EROSION AND SEDIMENT CONTROL PLAN

PROJECT NUMBER: 218113

ESCP COVER SHEET

**ESCP
OFFISTE
SE MAIN AVE.**

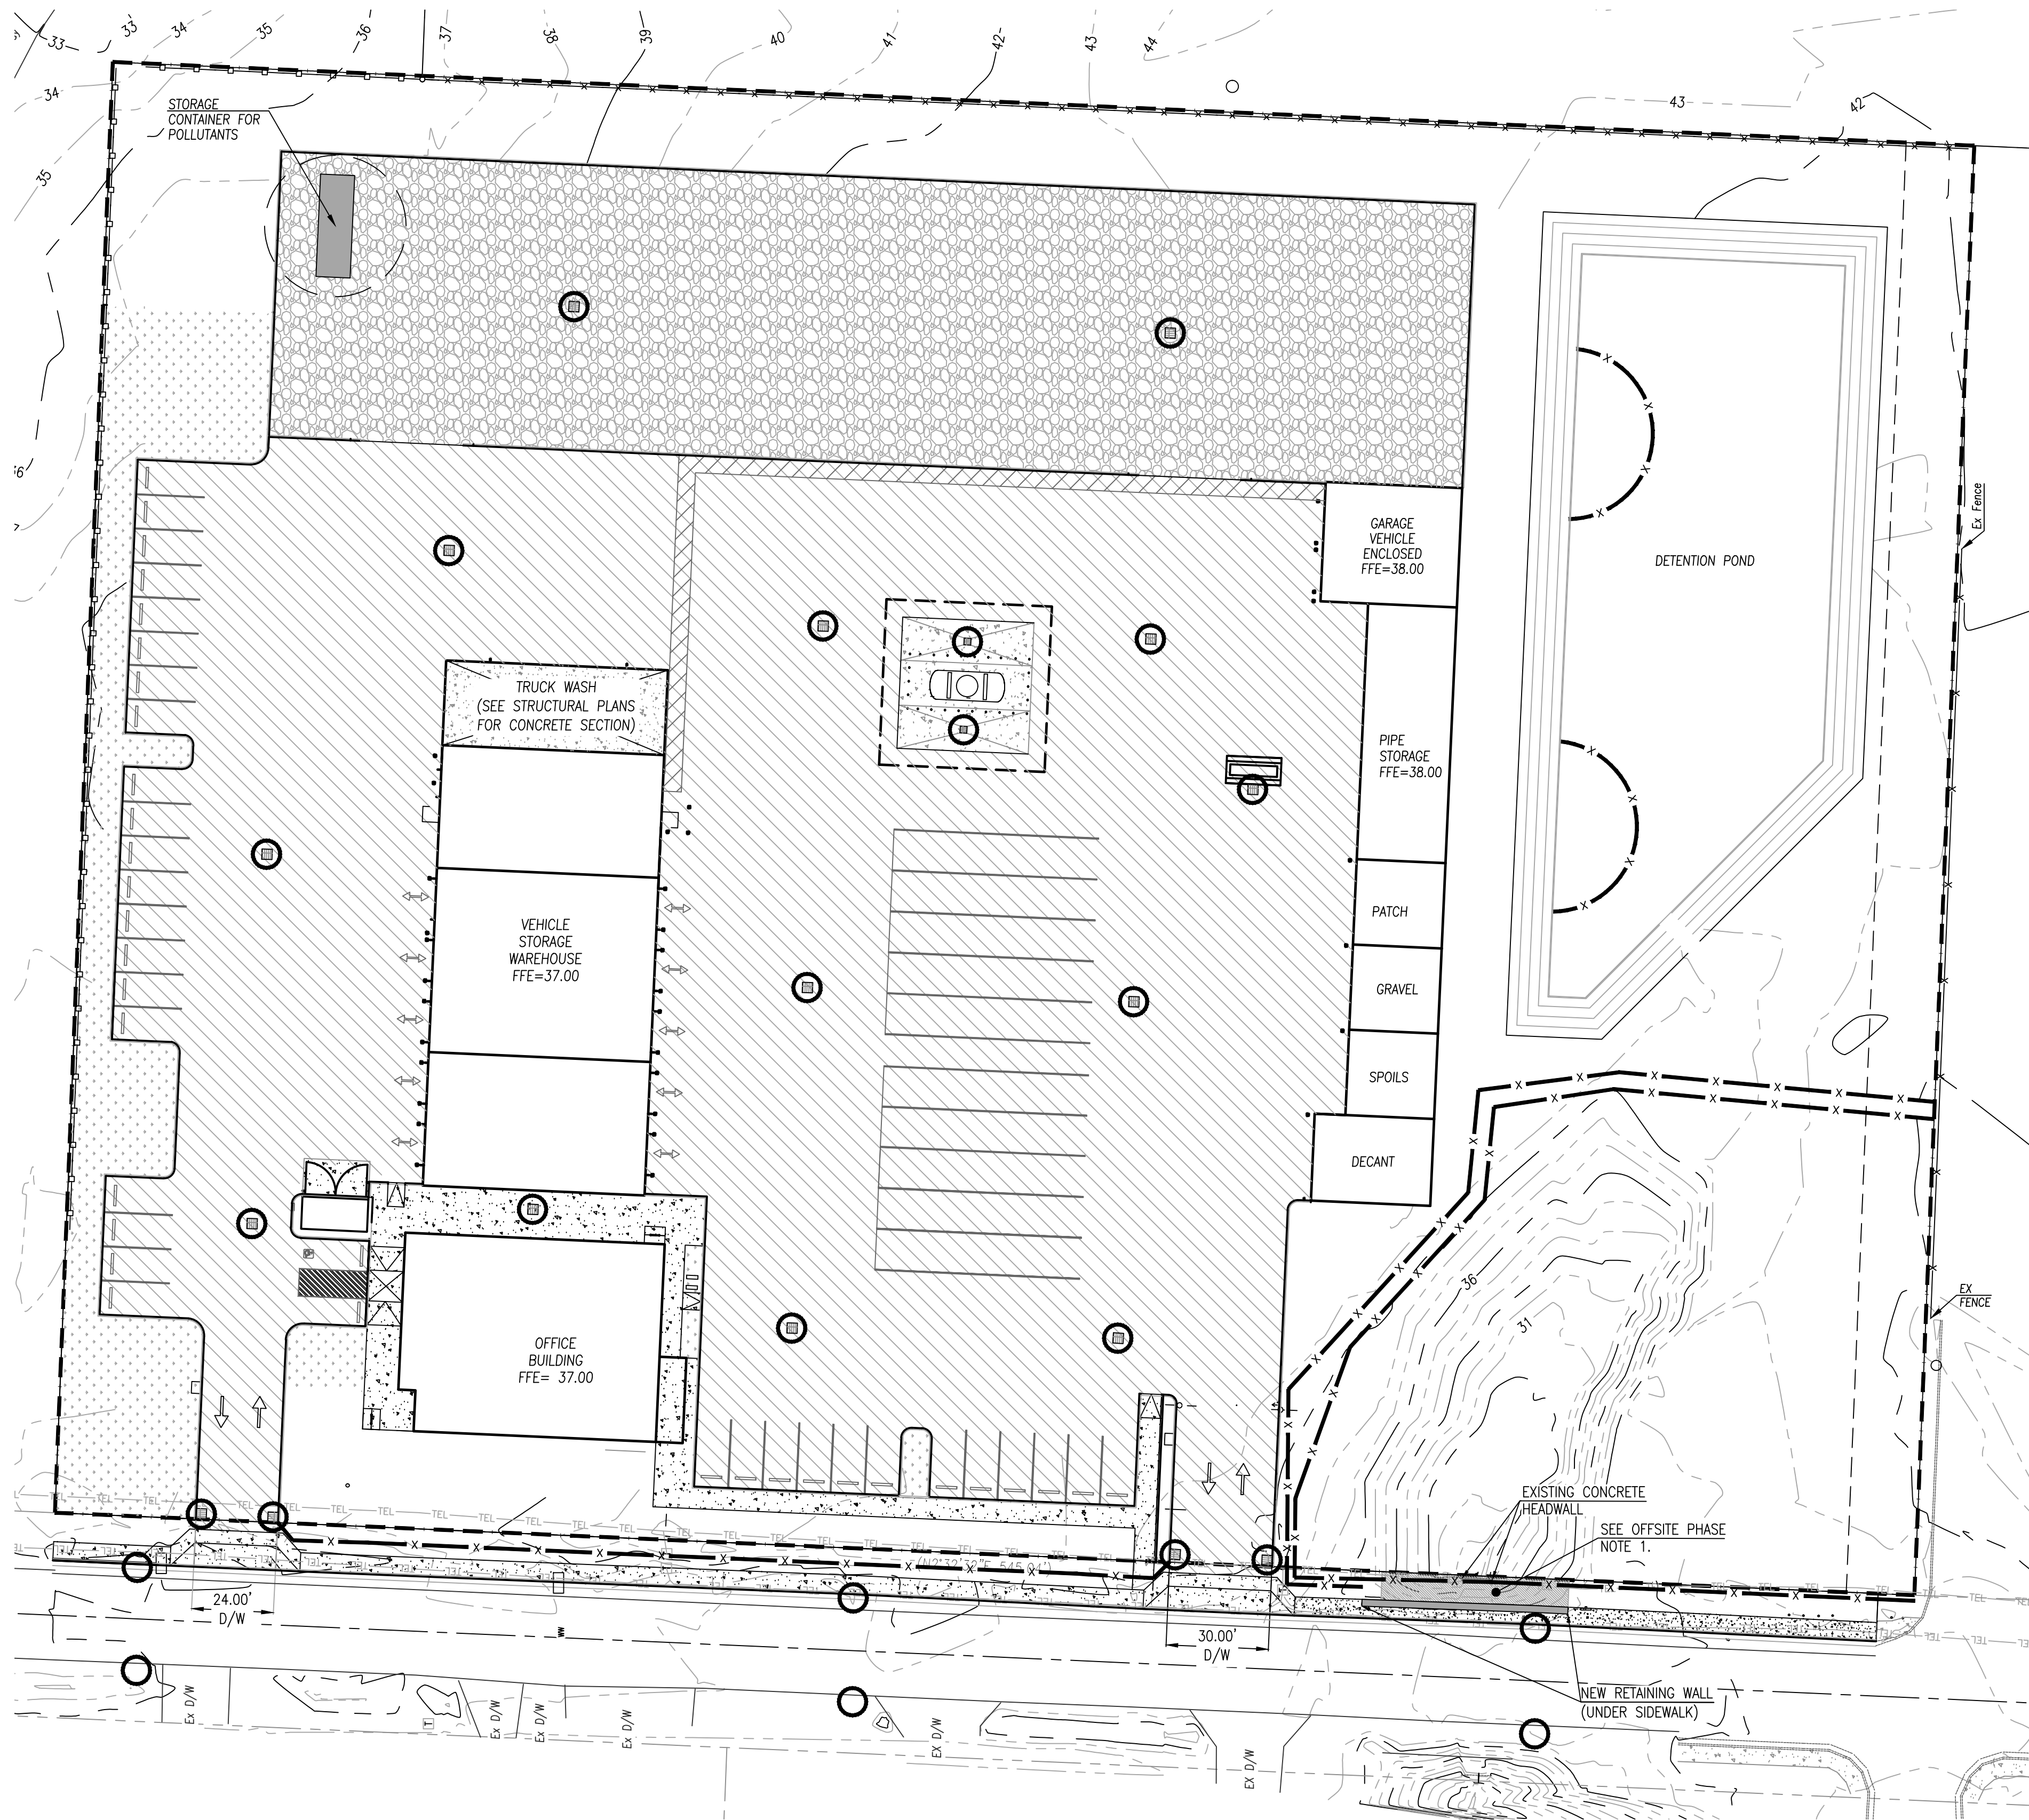
IF SURFACE WATERS ARE RETAINED ON-SITE, THE
NATURAL BUFFER IS MEASURED FROM THE EDGE
OF THE WATERBODY TOWARD THE UPLAND.
IF LESS THAN 50' OF THE NATURAL BUFFER IS
MAINTAINED, BE SURE TO PROVIDE ADDITIONAL
SEDIMENT AND EROSION CONTROLS AND THE
RATIONALE FOR CHOOSING THE SELECTED BMP(S).

SHEET TITLE:
**ESCP
VERTICAL
CONSTRUCTION
PLAN**

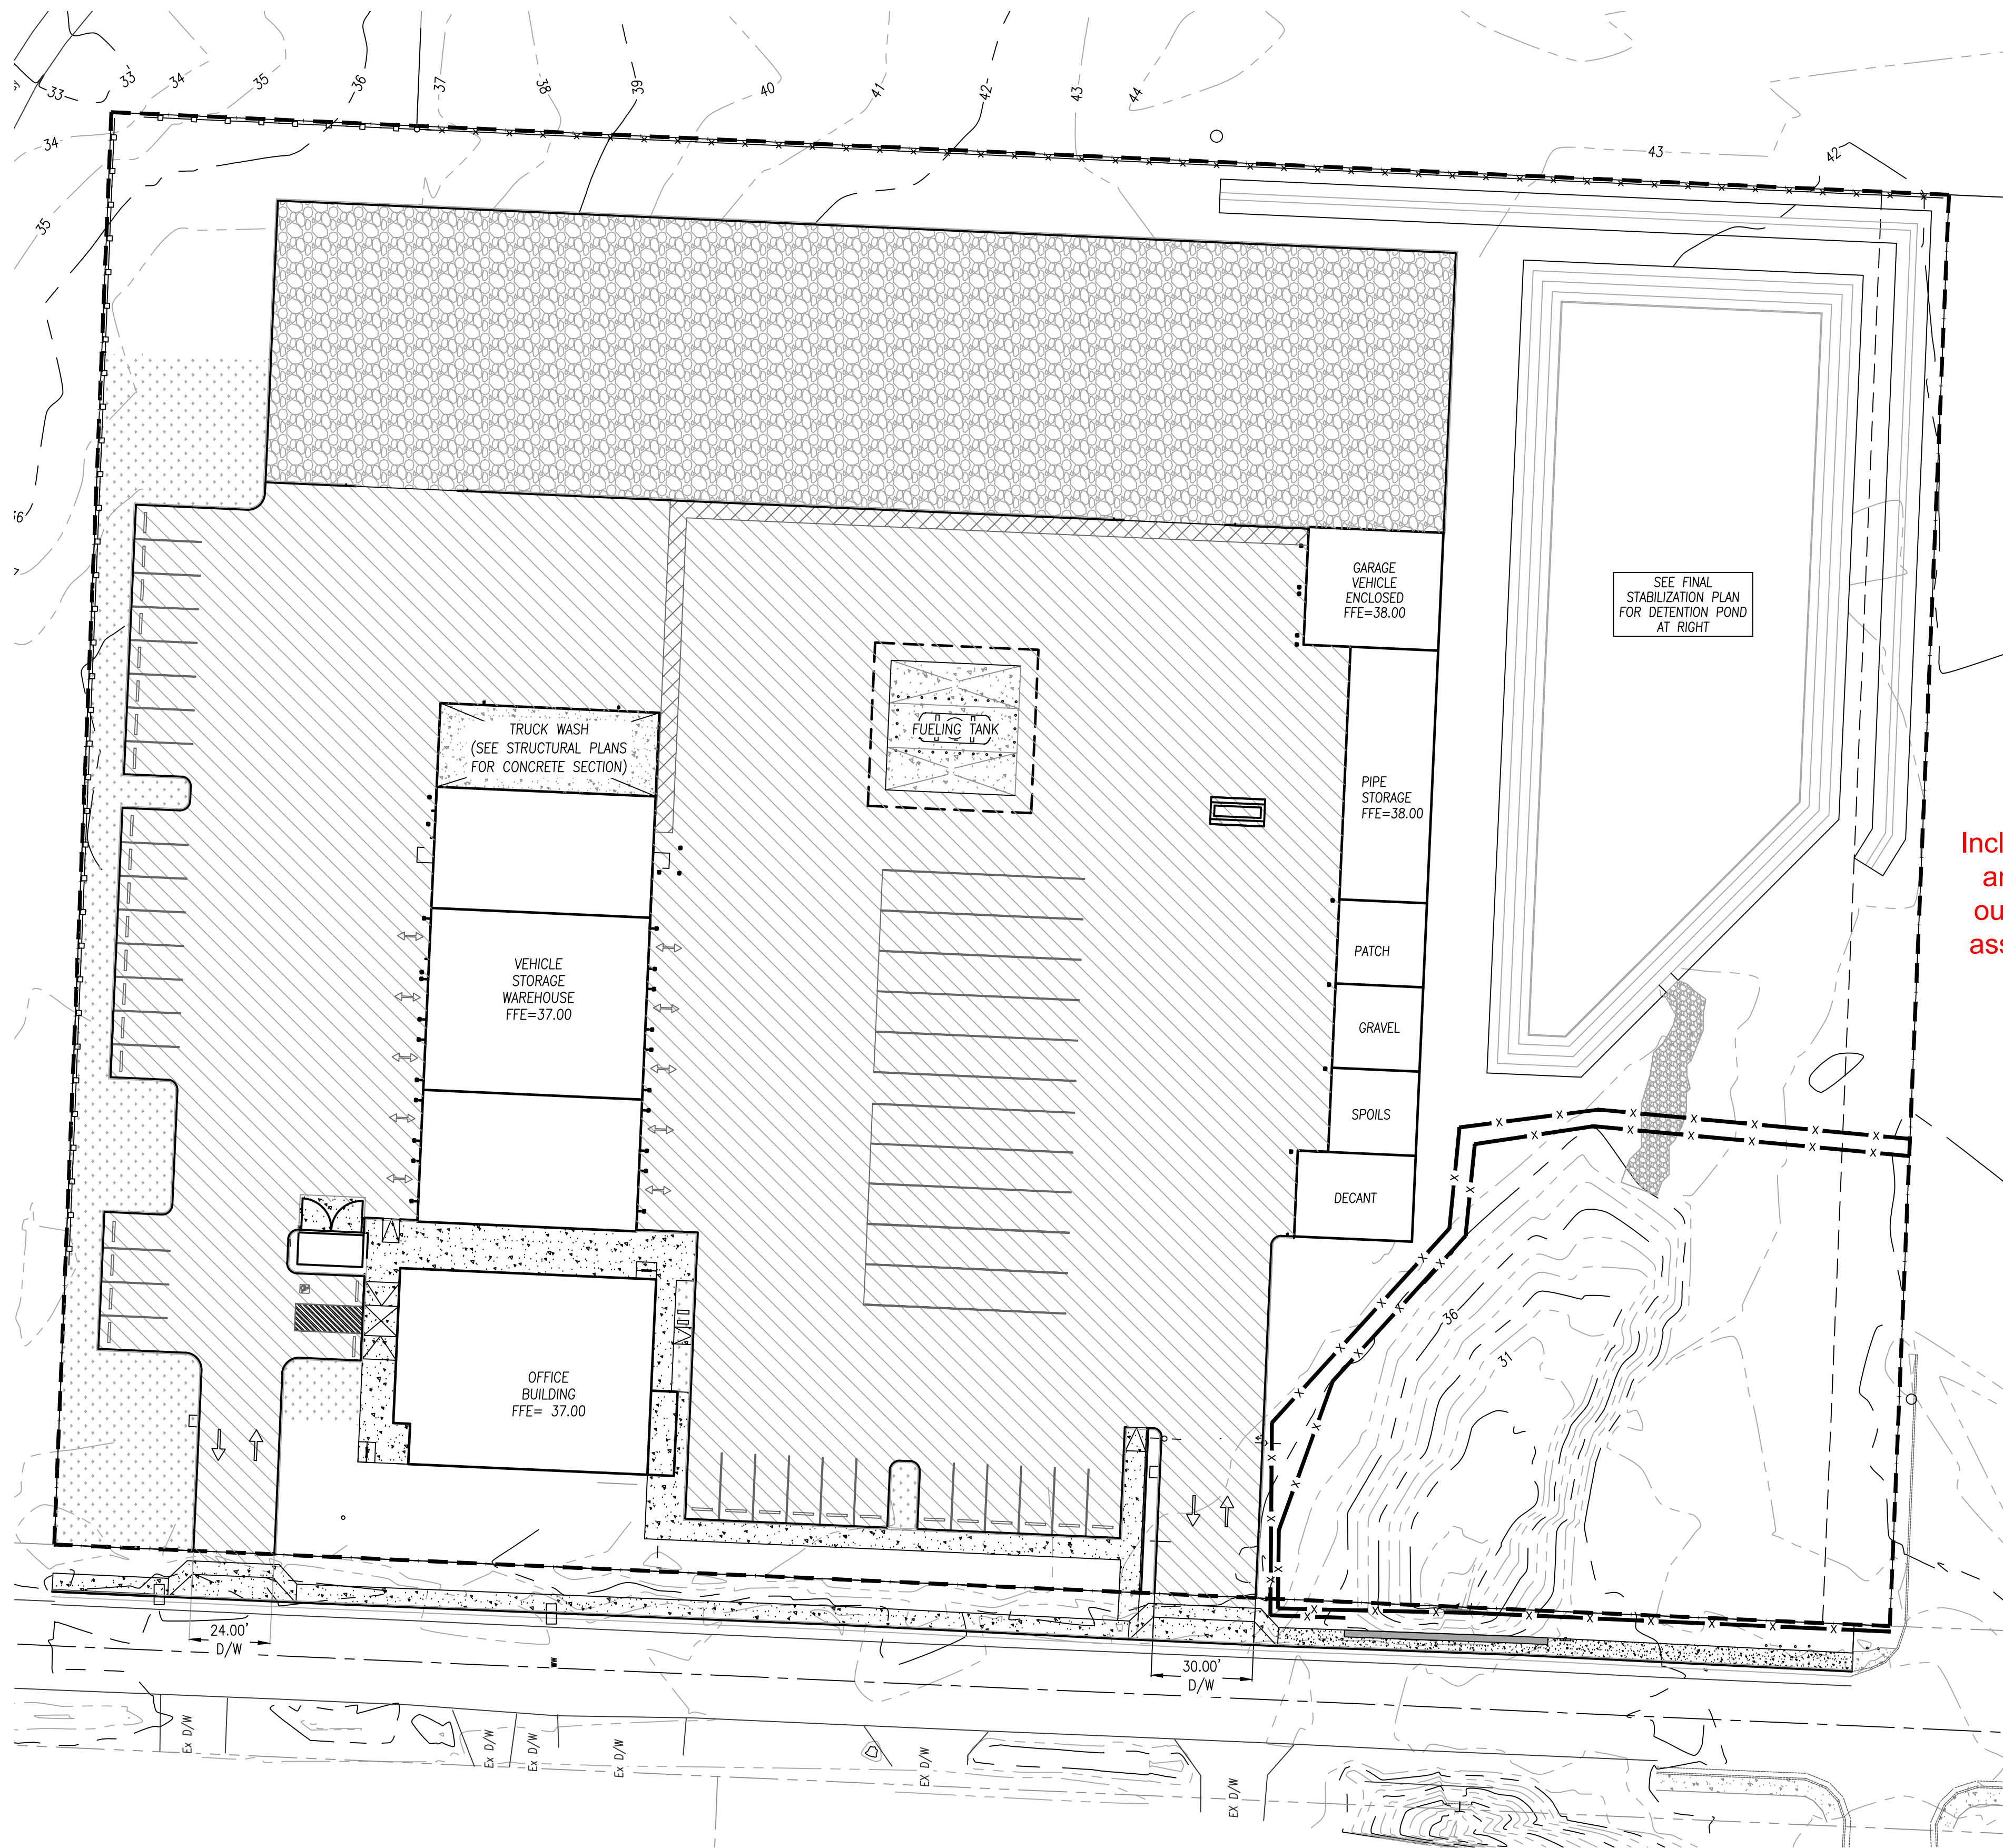
Continue to be mindful of data crowding throughout the plan. Only provide information necessary to the specific stage.

ESCP
FINAL LANDSCAPING
AND STABILIZATION
PLAN

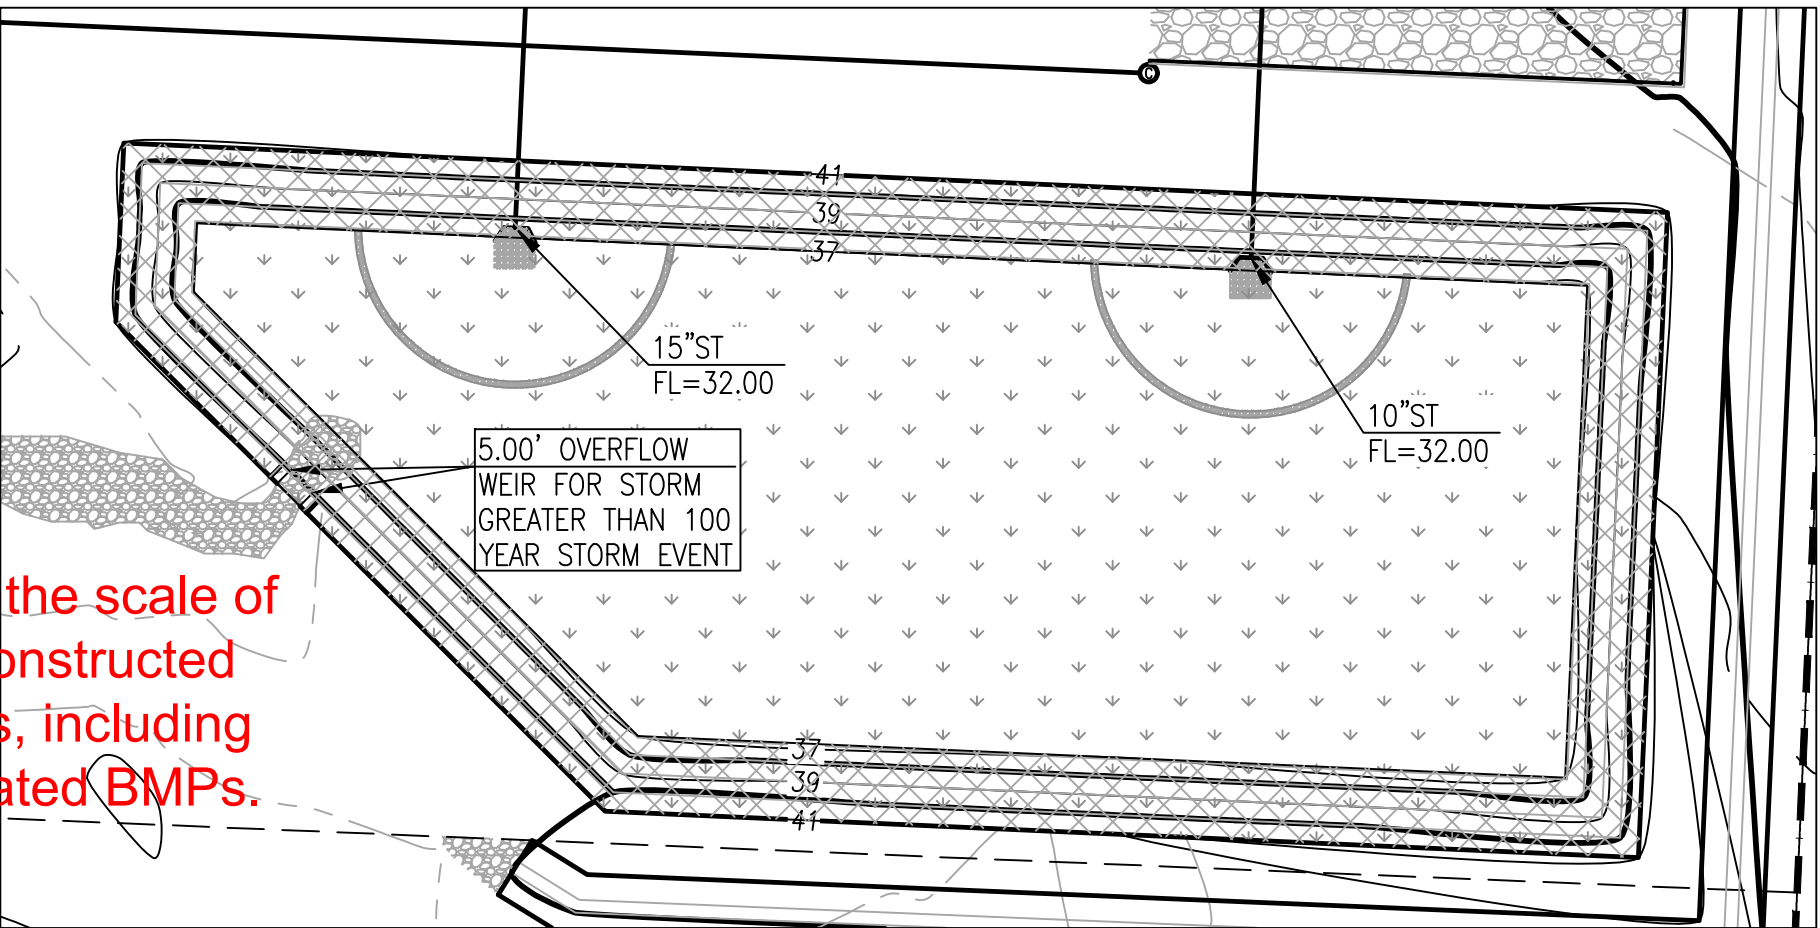
Include the scale of any constructed outfalls, including associated BMPs.

Onsite detention is a great BMP for stormwater management/treatment. Remember to stabilize the infrastructure prior to use so it does not become a sediment source itself. Consider long term functionality impacts if the feature will be used for post-construction stormwater management.

Note: There are no defined wet/dry seasons or dates in the 1200-C permit, or allowance for the assumption of dry conditions. The site is expected to manage stormwater any time of year.

ADD BASIN RESTORATION PLAN, TYPICALLY "EXCAVATE TOP 18" AFTER CONSTRUCTION ACTIVITIES CEASE AND FINAL STABILIZATION IS ACHIEVED. ADD 18" OF APPROVED GROWTH MEDIA BEFORE VEGETATING".
